# SERVICE BULLETIN

# Seat Model 2041 Crew Seat Armrest Removal

Document No: SB2041-25-20-03

Revision: IR

Figure 2.1 Modification ID Label and Protective Film Location

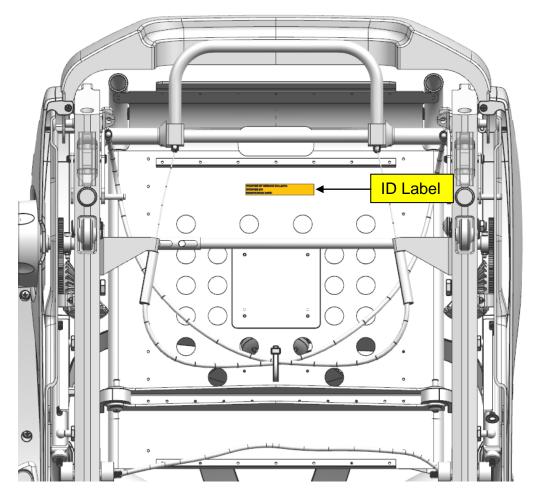
The new SB label should be installed on the bottom side of the seat pan approximate as shown in Figure 2.1

A. Install 9000-1130008-001 Modification ID Label approximately as shown in Figure 2.1 and apply the 9000-1130008-003 Protective film over the new label, approximately centered.

Figure 3.2 Side Shroud, Recline Handle and Armrest Cover Removal

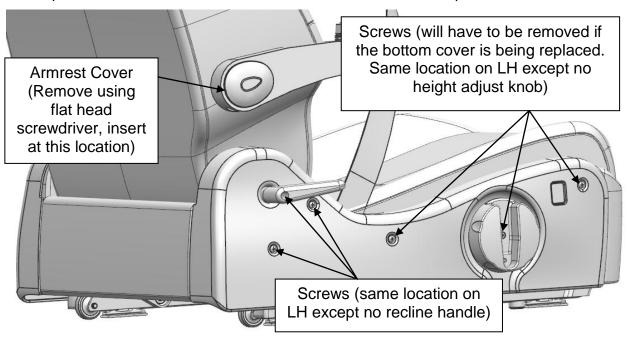
- C. Remove armrest cover using the flat head screwdriver to pop the cover out of the armrest. See Figure 3.2.
- D. Remove the armrest assy by removing the armrest bolt. See Figure 3.3.

- E. Remove the recline handle by removing the screw. See Figure 3.2.
- F. Loosen the side shrouds (LH & RH) by removing four screws (two on each side). See Figure 3.2.

Figure 3.3 Front/Back Shroud, and Armrest Assy Removal

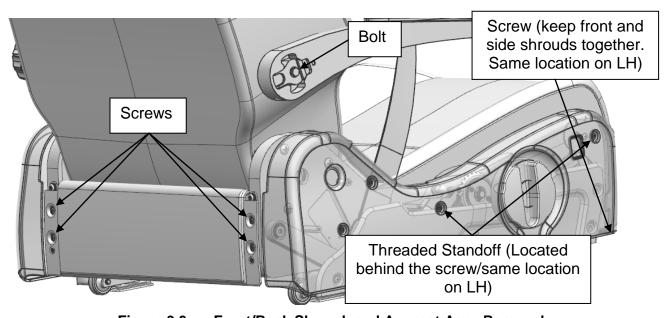
- G. Remove the back shroud out of the frame by removing four screws. See Figure 3.3.
- H. Unhook the rear flap of the bottom cover to get better access to the J- and Arrow retainer at the bottom of the backrest cover. See Figure 3.4.

Figure 3.4 Backrest Cover, Armrest Hub Removal

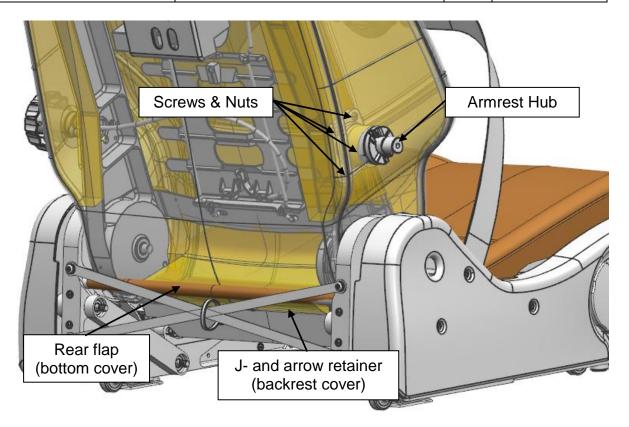
- I. Unhook the J- and arrow retainers at the bottom of the backrest cover by peeling the rear part of the cover upward with 2-3 fingers. This rotates the arrow out of the J-retainer. See Figure 3.4.

Figure 3.5 Armrest Cover Installation

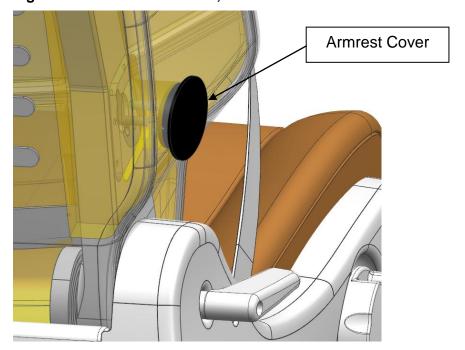
- L. There is an option:
  - (1) If MKIT2041-25-20-03-C is used in this modification then install the armrest cover in this kit using the two springs provided. Hook the springs onto the holes in the backrest beam then hook the other ends onto the armrest cover. Adjust the armrest cover around for the best fit (See Figure 3.5). Re-install the backrest cover, bottom cover, back shroud, side shroud and recline handle in reverse steps above. Ignore step M thru U below.

Figure 3.6 Headrest Spring Removal

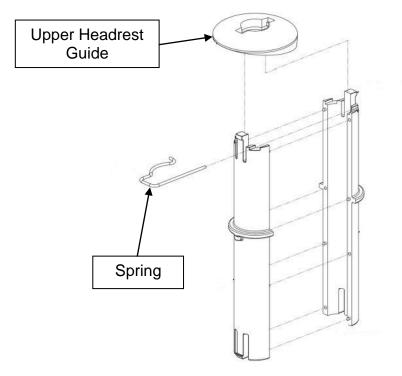
- N. Remove the headrest assy by pushing down the backrest cover on the backside of one of the plastic headrest guides and pull the spring out directly aft from underneath the upper part of the guide. Remove the headrest assy out of the seat frame then remove upper headrest guide. See Figure 3.6.

Figure 3.7 Restraint Guide Removal

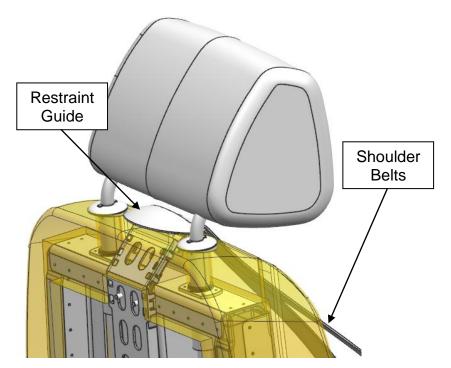
- O. Remove restraint guide by pulling up the restraint guide at the front to release the plastic tabs. See Figure 3.7.
- P. Repeat the step "J" above then continue rolling it inside out. Note: the hook and loop fastener used to fasten the cover to the cushion is very strong. Use one hand to hold the cushion in place and with the other hand gently peel was the backrest cover to prevent tearing the hook tape from the cushion.

- Q. Disconnect the shoulder belt from the restraint system rotary buckle (if needed) then feed the shoulder belt through the slot in the cover. See Figure 3.7.

Figure 3.8 Lumbar Knob Removal

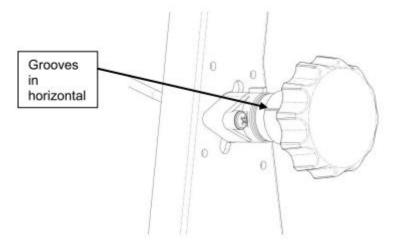
- (2) If MKIT2041-25-20-03-U is used in this modification then continue steps below.
- M. Remove the lumbar knob by pushing in the cover and foam around the knob towards the center of the seat so the shaft of the knob becomes visible. Rotate the knob such

that the one of the grooves in the knob shaft are at the top (see Figure 3.8). Pry the knob up and simultaneously pull the knob away from the seat. There should an audible sound of snaps disengaging from the actuator.
